Contractor:  TIANCHEN CORP. CHINA	Project :	MKP Methanol Project			Owner :  شرکت کیمیای پارس خاورمیانه Middle East Kumiya Pars Co.
	Unit	General Technical	Phase	Detail Engineering	
	Doc. Title :	PACKAGE HAZOP			
Vendor :  新鼎信息技術(上海)有限公司 Advanced Control & Information Technologies Co., Ltd.	Owner No.	MKP-11-DE-9000-SF-RPT-001B			Rev. : 0
	Contr. No.:	MKP-11-DE-9000-SA01-RPT-001B			
	Vendor No.	16E2416A			Page : 1 of 25

PACKAGE HAZOP

Node 2008

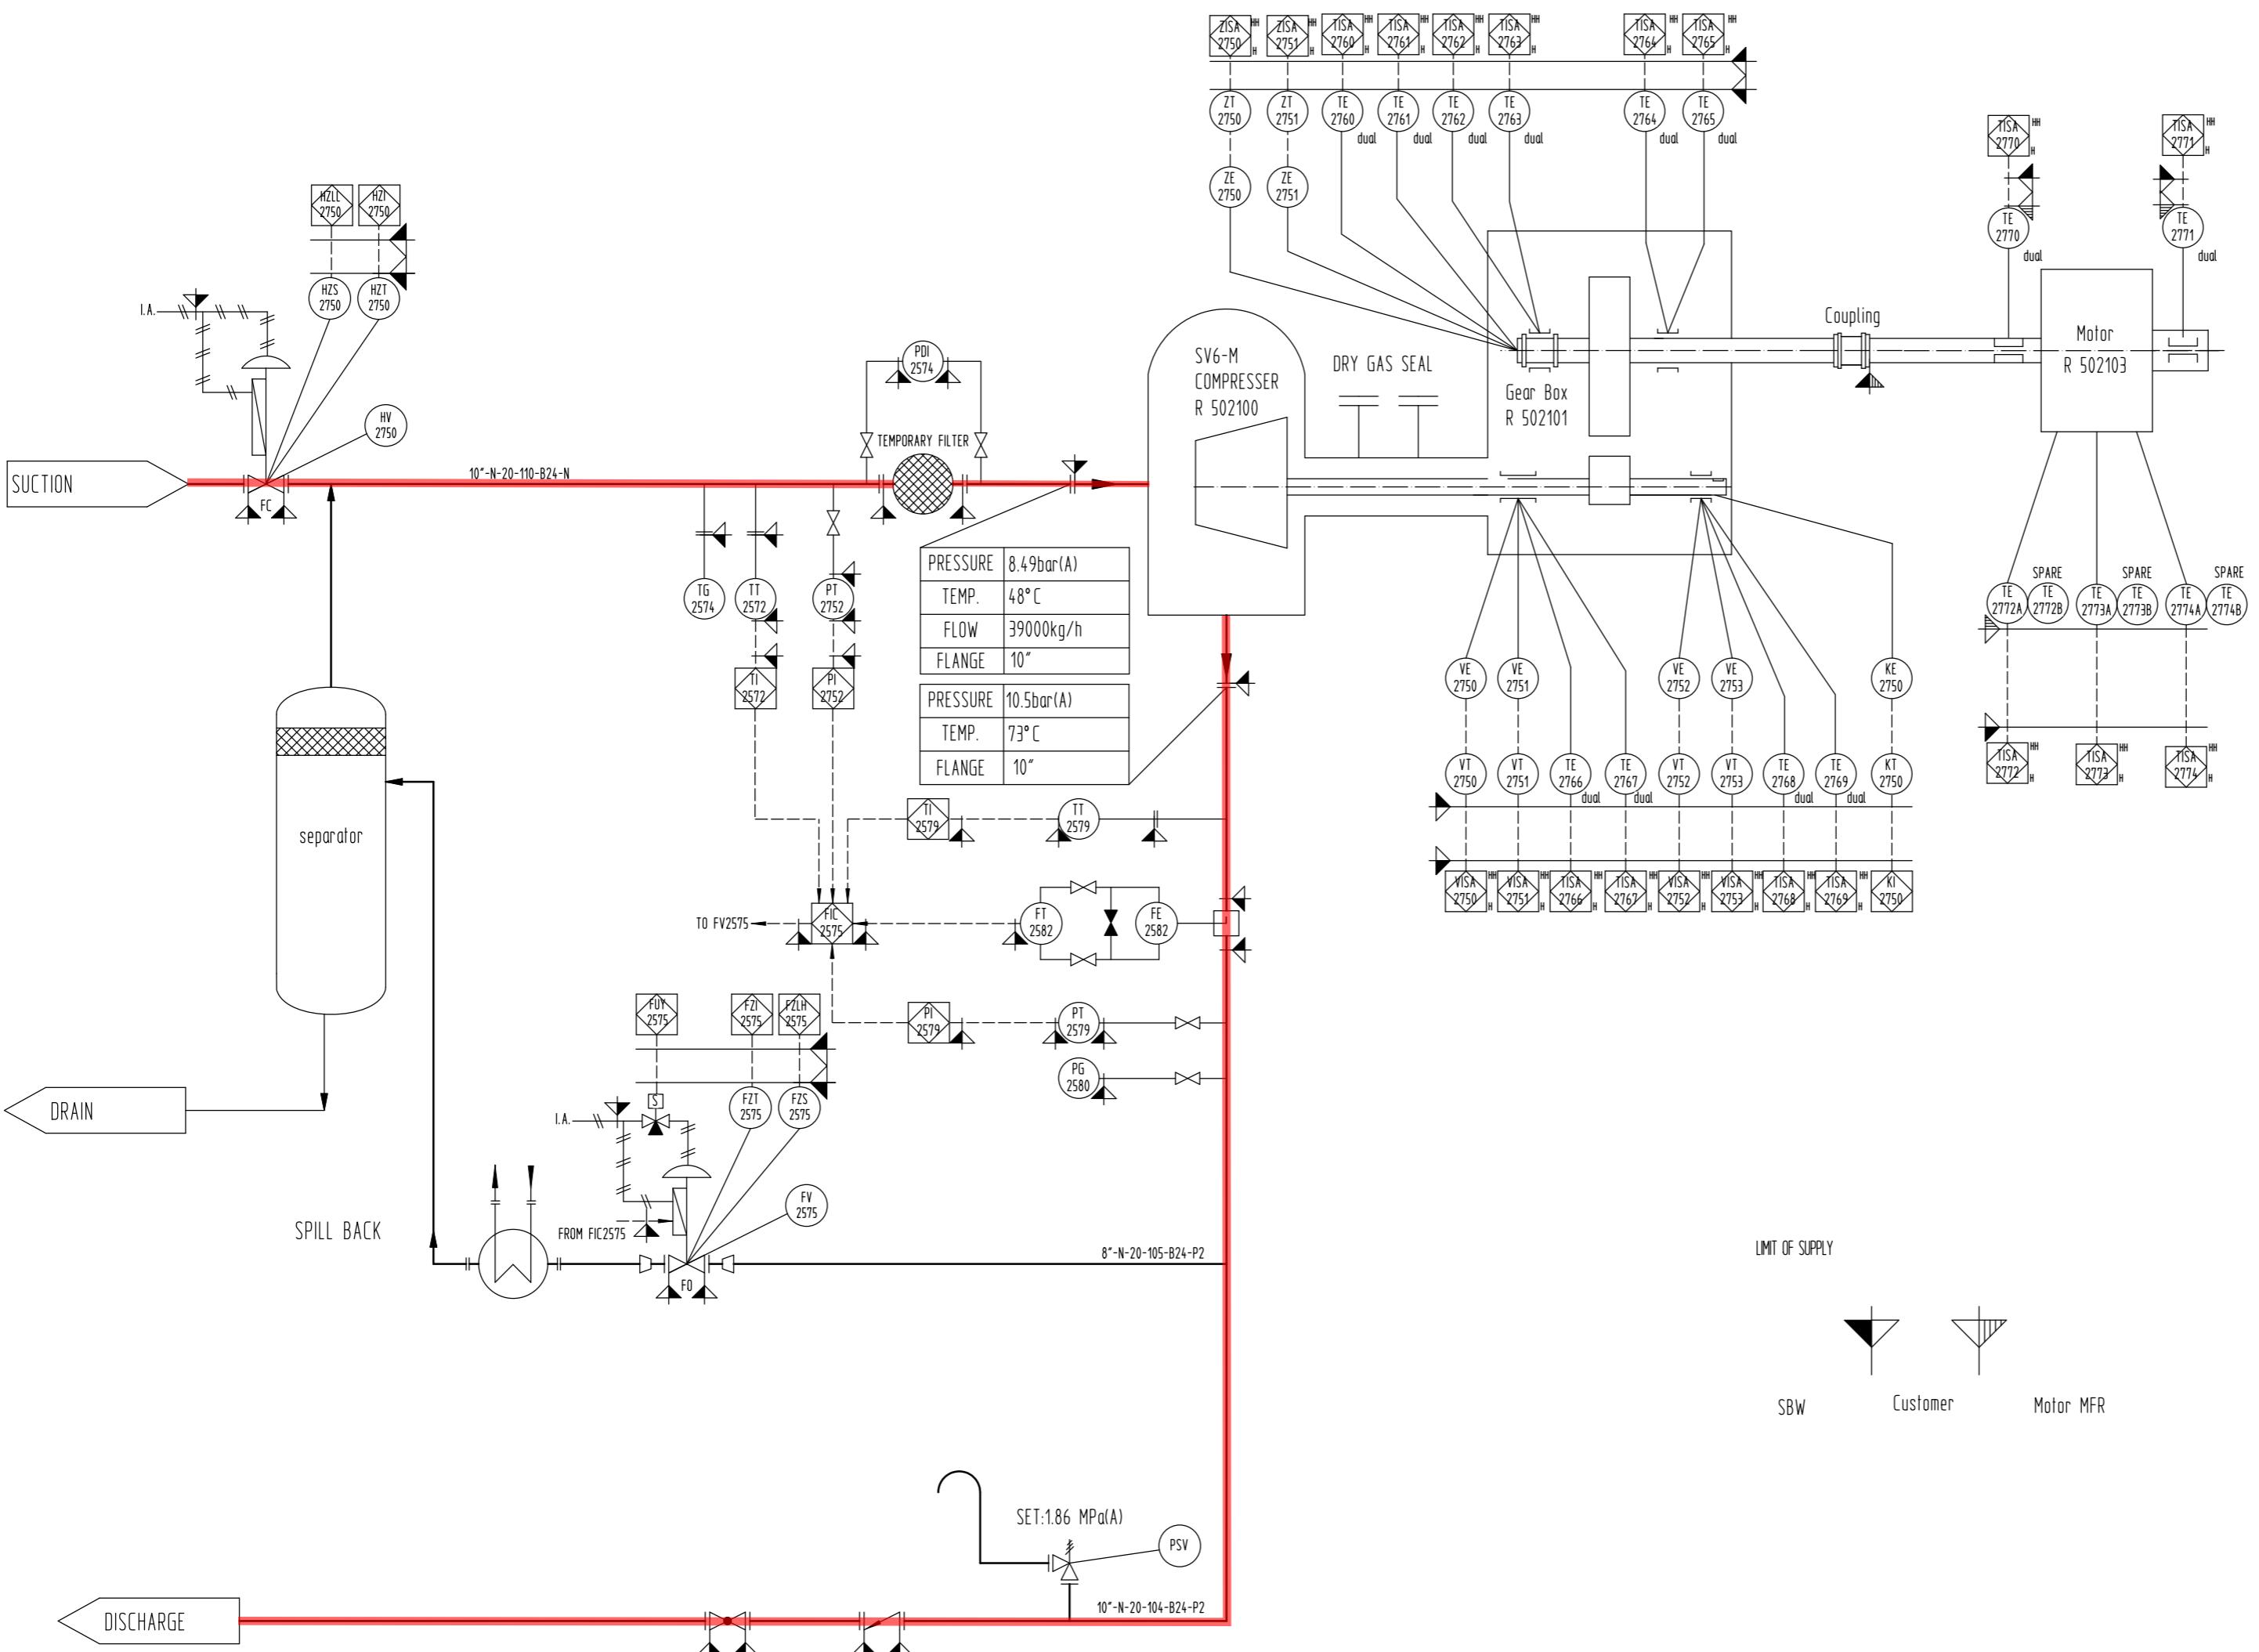
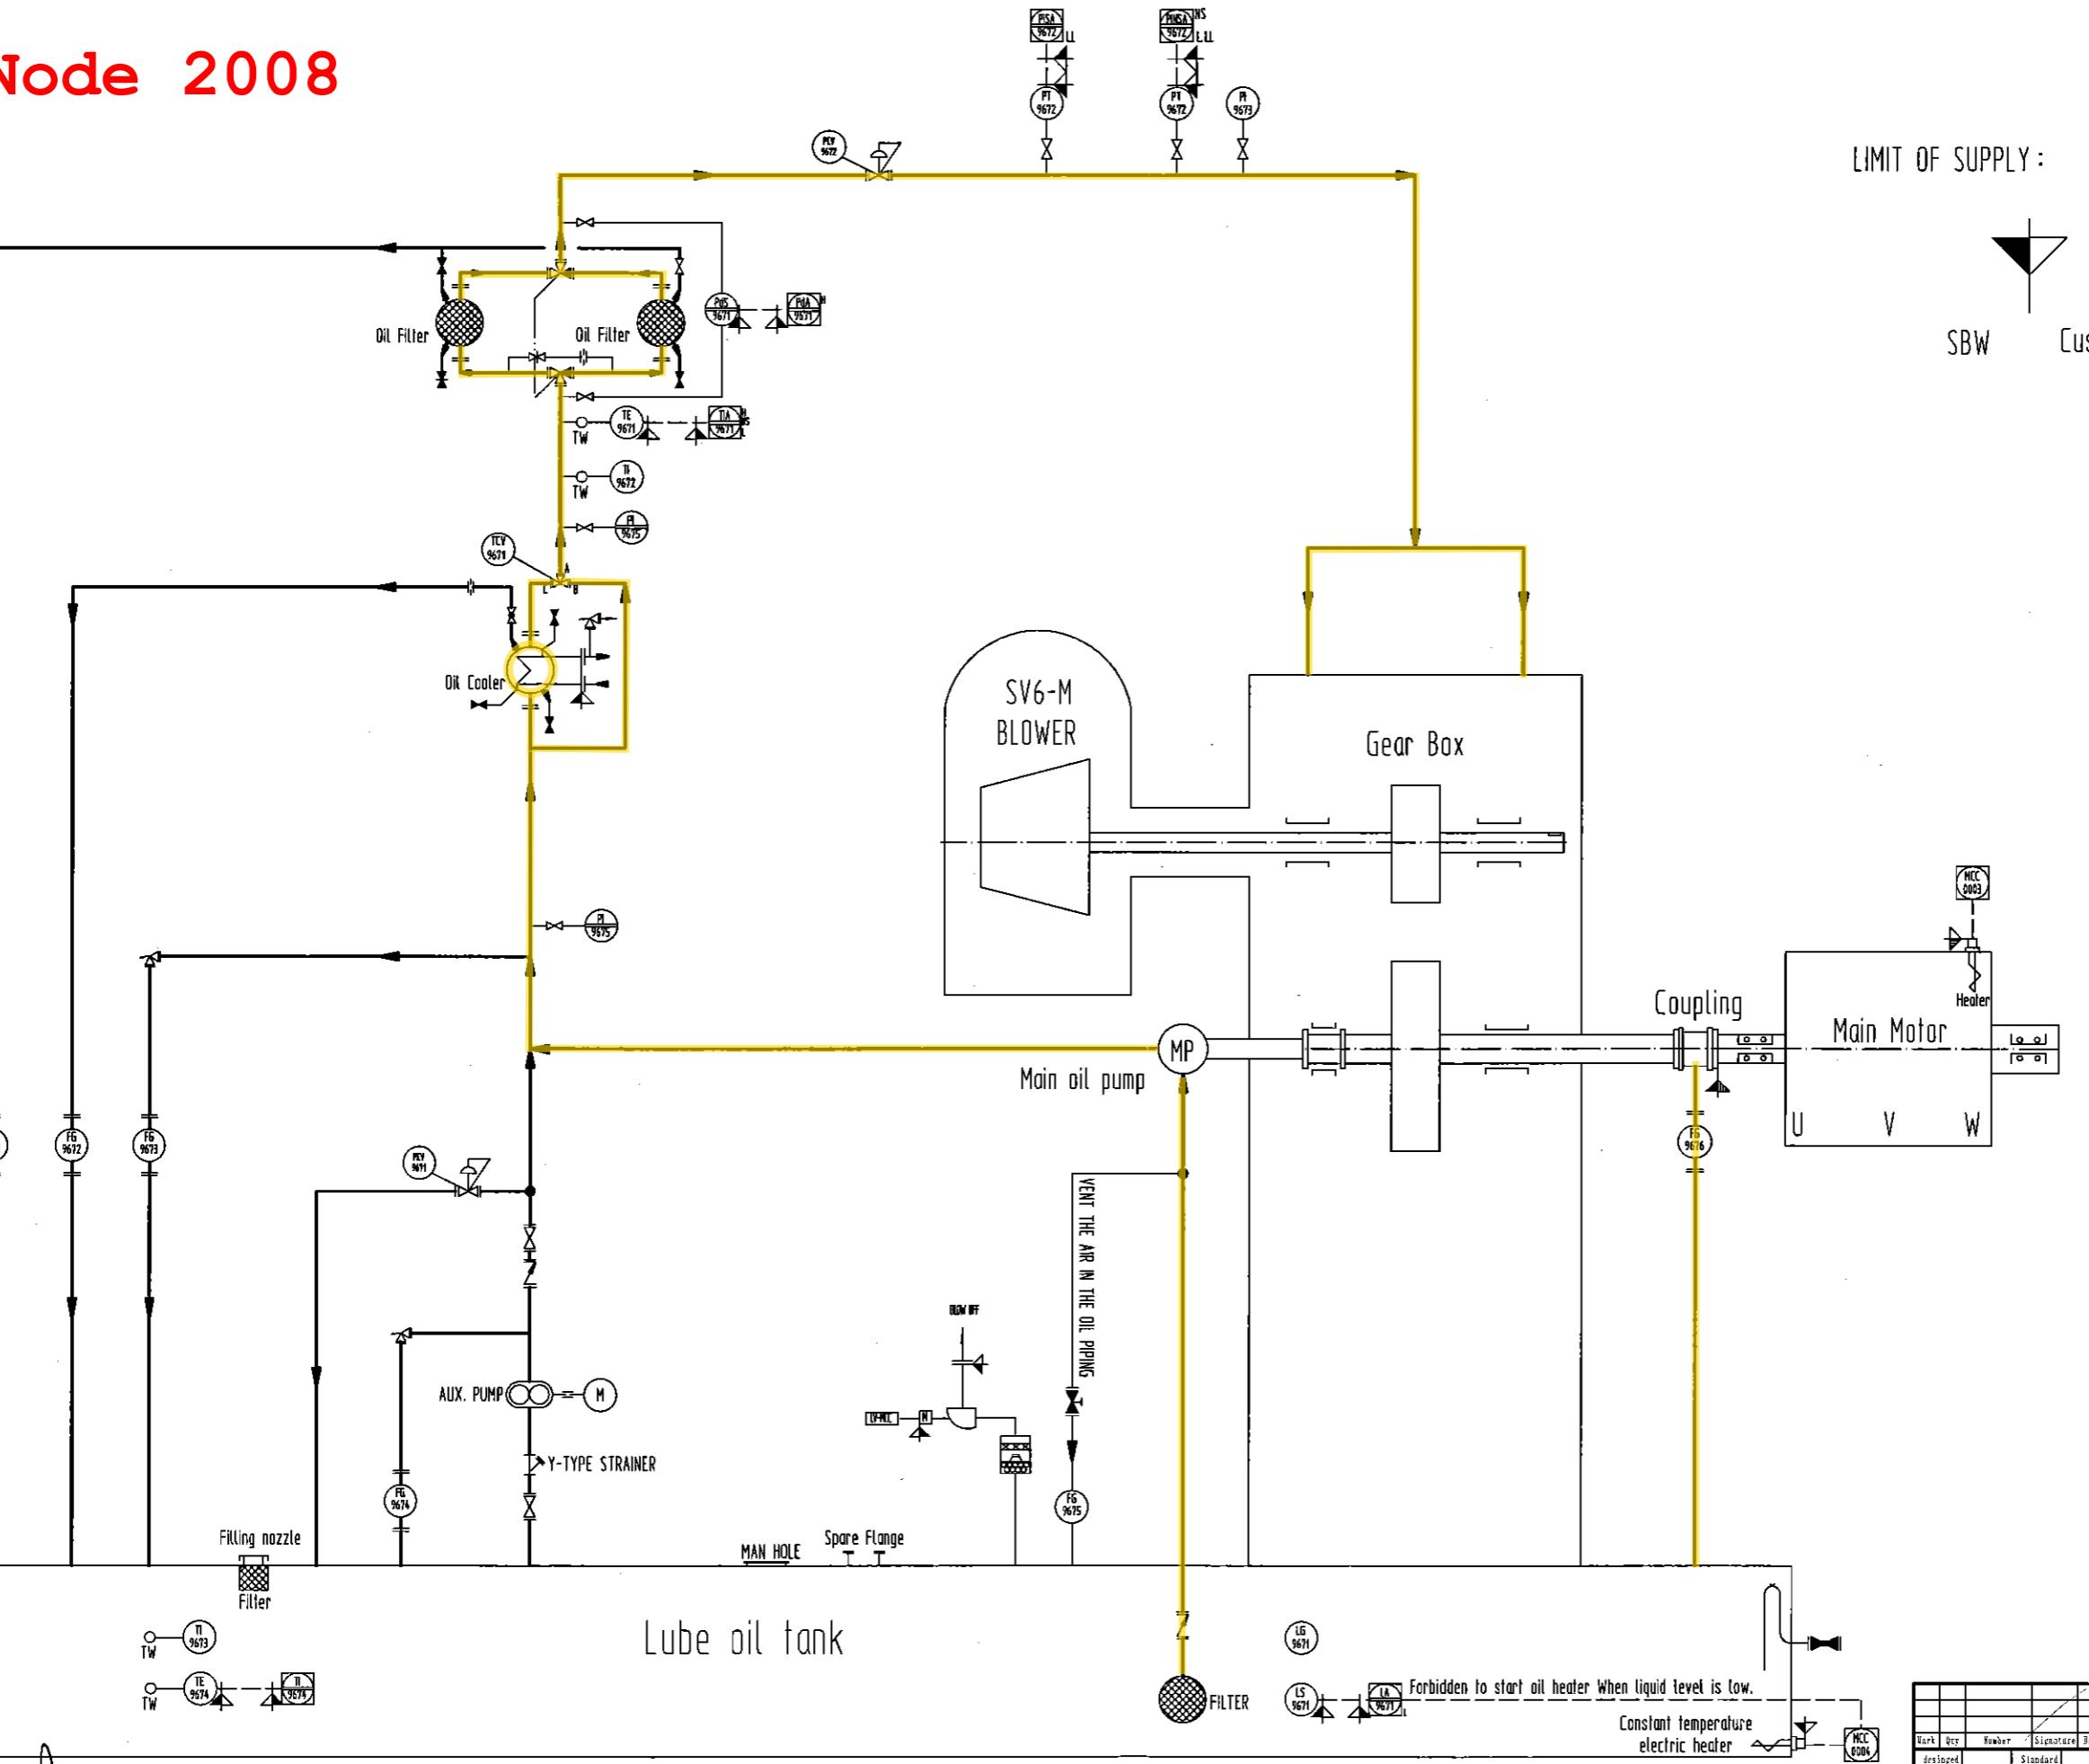
2008.4	2	Show check valve and manual valve on 2000-PID-018	Y			TCC
2008.7	2	PI-2579 add high pressure alarm.	Y			SBW
2008.9	1	Lube oil supply main line PT-9672 add high pressure alarm.	Y			SBW
2008.13	2	Show the autostart of lube oil heater in P&ID.	Y			SBW
2008.15	3	LS-9671 low level alarm change to low low level trip.	Y			SBW
2009.3	2	PDI-2811 add high d/p alarm.	Y			ITT
2009.7	1	Add desuperheater on the LP steam header.	Y			TCC
2009.8	1	1.PDI-2811 add high d/p alarm. 2.Add TI-2801 low temperature alarm.	Y			ITT
2009.9	2	Add blind flange after the drain valve.	Y			ITT
2009.13		Due to incomplete data of P&ID for MF-2001, it will be checked later. TCC shall be issued completed P&ID like other MV motors of plant and consider auto start and relevant signals for it.	Y			ITT/TCC
2010.3	2	PDI-2861 add high d/p alarm.	Y			ITT

. 3	incorrect flow direction	1 non actual hazard identify						N	
. 4	reverse flow	1 Trip of C-2001.	Back flow.	Check valve on discharge line.	2	4	2	N	Show check valve and manual valve on 2000-PID-018
. 5	part of flow/composition	1 non actual hazard identify						N	
. 6	as well as flow/impurity	1 non actual hazard identify						N
